Index 544-001 Crash Cushion Transition Details

COMMENTS AND RESPONSES

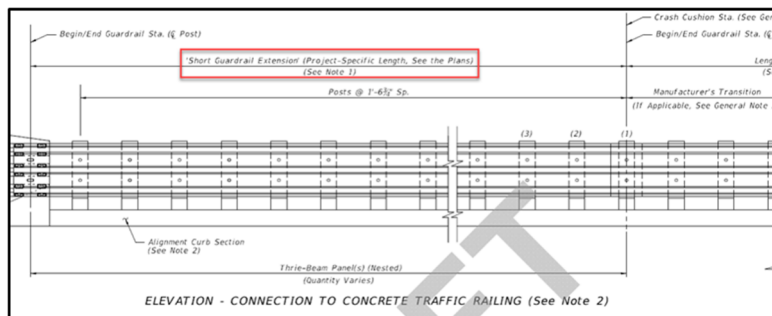
Regarding the new crash cushion details sheet (Sheet 3 of 3 shown below), it is unclear what minimum length of guardrail extension is considered 'short' as described in the index. Consultants and Reviewers will be confused when they would need to use the 1'-6

¾" post spacing called out. The index should call out the minimum number of panels to get the quarter post spacing.

The callout highlighted references Note 1, which reads, "Short guardrail extensions are typically used where adding length to a barrier system is warranted, but a full Approach Transition Connection to Rigid Barrier will not fit." Additionally, the SPI for 544-001 will explain usage of this short guardrail extension. Basically, any other Standard option for placing guardrail between concrete traffic railing and a crash cushion requires lengthy stiffness transitions, and these transitions to w-beam may not fit projects or may not be practical. This proposed "short guardrail extension" provides a shorter, simplified option.
